TO: Robert Palmer, Strategic Land Solutions, Inc.
FROM: Cynthia Thye, Planner I
DATE: November 6, 2025
SUBJECT: SP24-012: Parker Central Area F5 L2 B1 - McDonalds– Site Plan Amendment Review Comments 03

SITE DEVELOPMENT PLAN
MCDONALDS REMODEL AT PARKER CENTRAL AREA
FILING NO. 5, BLOCK 1, LOT 2

PARKER CENTRAL AREA FILING NO. 5, BLOCK 1, LOT 2, TOWN OF PARKER,
COUNTY OF DOUGLAS, STATE OF COLORADO.
ADDRESS: 10950 S. PARKER ROAD

2 EAST ELEVATION
SCALE: 3/16" = 1'-0"

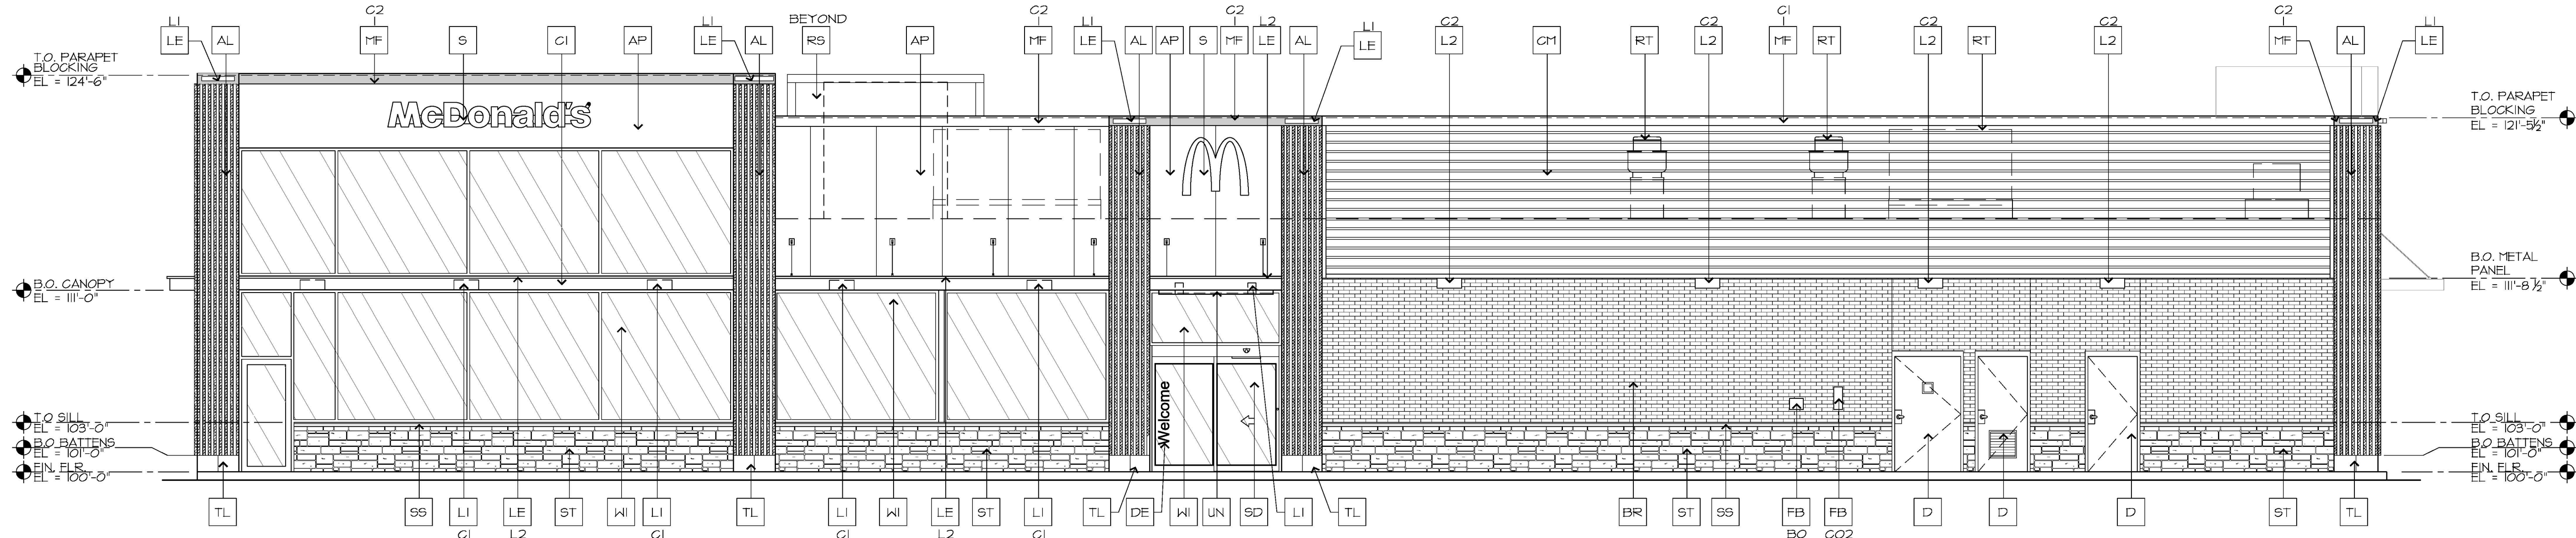
Everything Community Development is reviewing needs to be on these plans. Show guard rail on elevations and this site plan.

RESPONSE: GUARD RAIL ADDED TO WEST ELEVATION

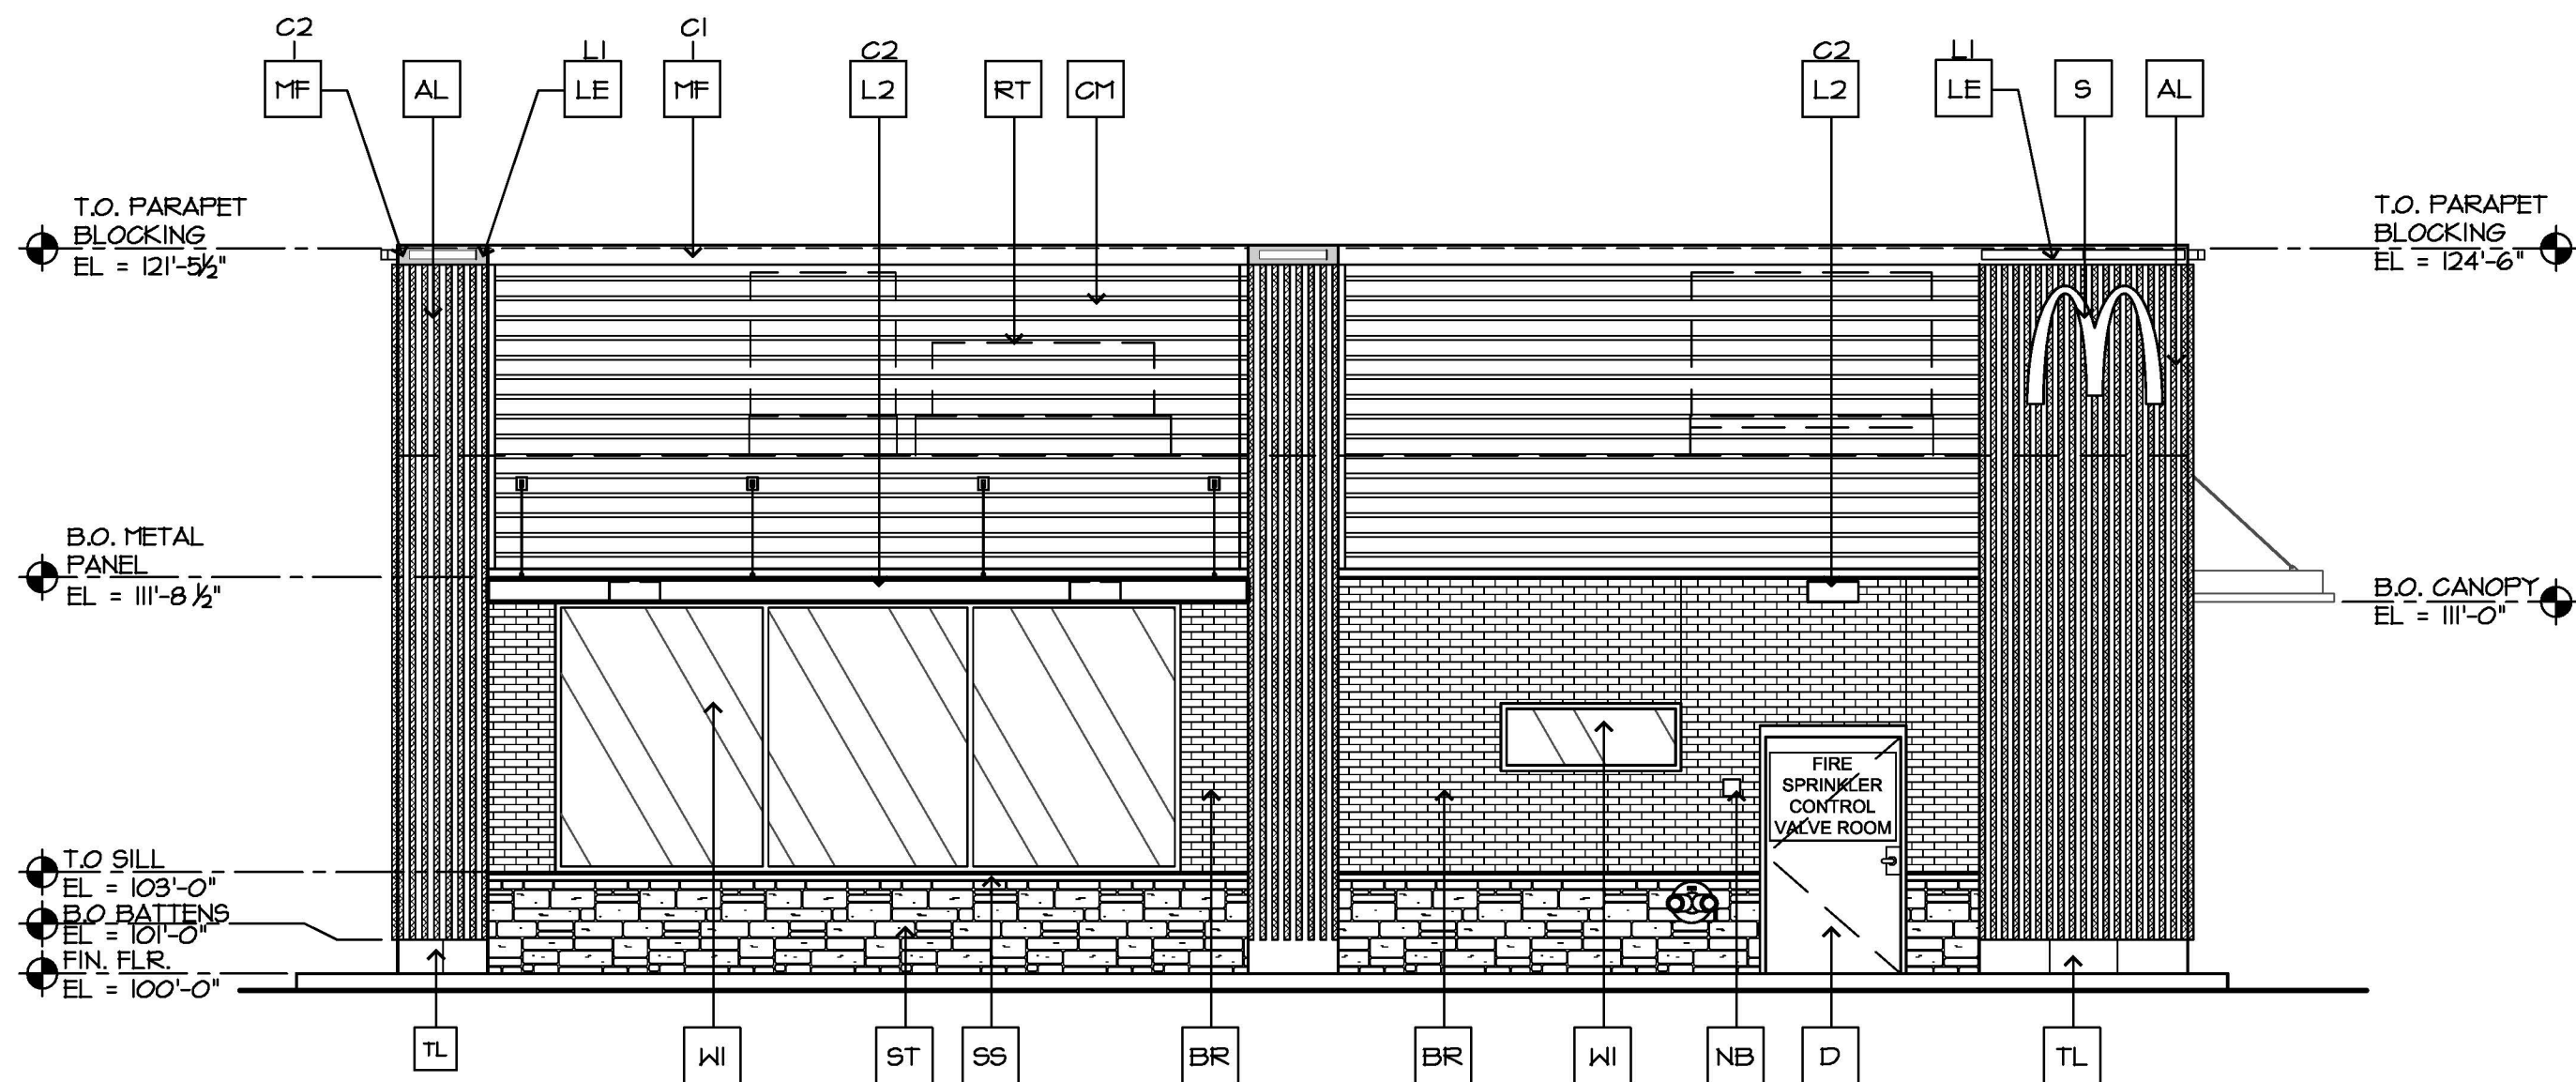
Per DDS X.A.2.c.i. 1-2, show transparency
calculations for all facades.

RESPONSE: TRANSPARENCY CALC. ADDED

2 WEST ELEVATION

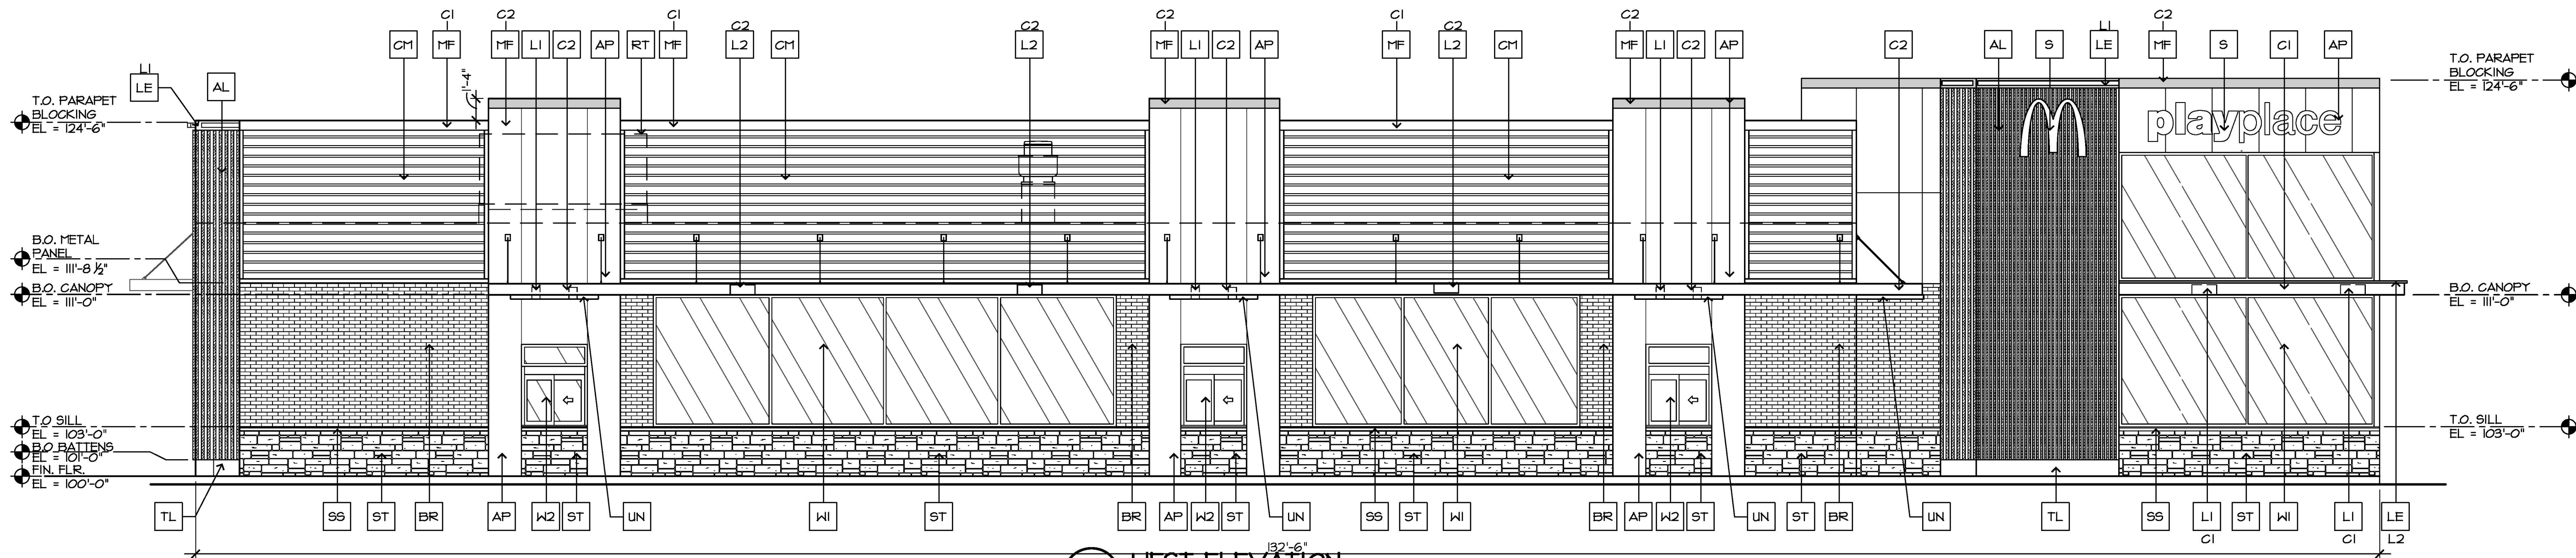
Show wall-mounted electrical equipment,
add note that it will be painted to match
adjacent wall.

RESPONSE: WALL-MOUNTED
ELEC. EQUIP. ADDED AND NOTE
TO PAINT TO MATCH

MATERIAL LEGEND

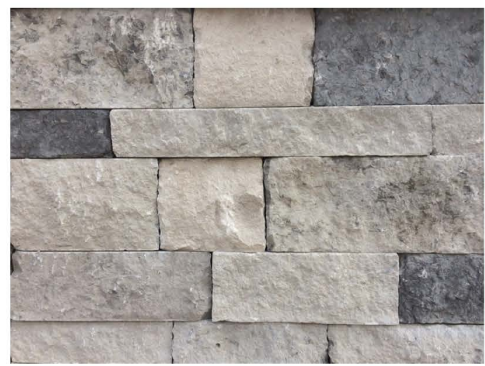
Note percent of
material.

RESPONSE: MATERIAL PERCENT
BOX WAS ADDED TO THE
B/W ELEVATIONS

2 EAST ELEVATION
SCALE : 3/16" = 1'-0"

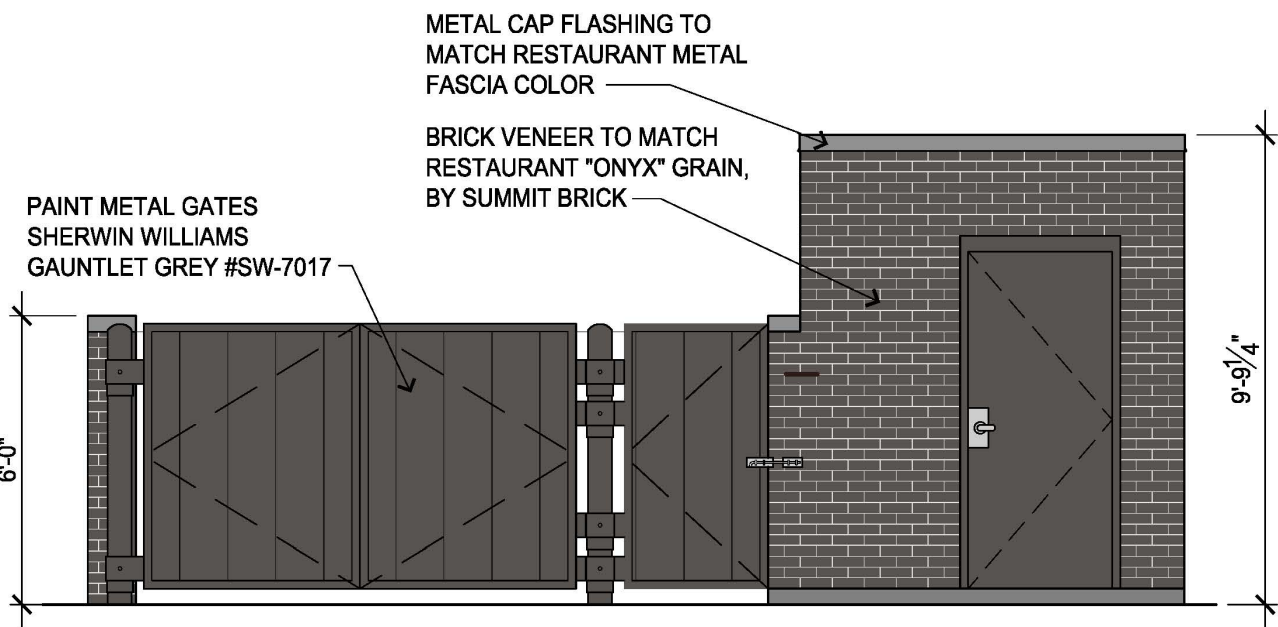
Need vertical massing break(s). Per
DDS X.A.3 b.iii.3). Buildings over 100
feet in length shall require a vertical
massing break at a distance of 25 to
50 feet.

RESPONSE: AN ADDITIONAL VERTICAL WOOD
BATTEN WAS ADDED ON THIS WALL AND A
CANOPY WAS ADDED OVER THE DOORS
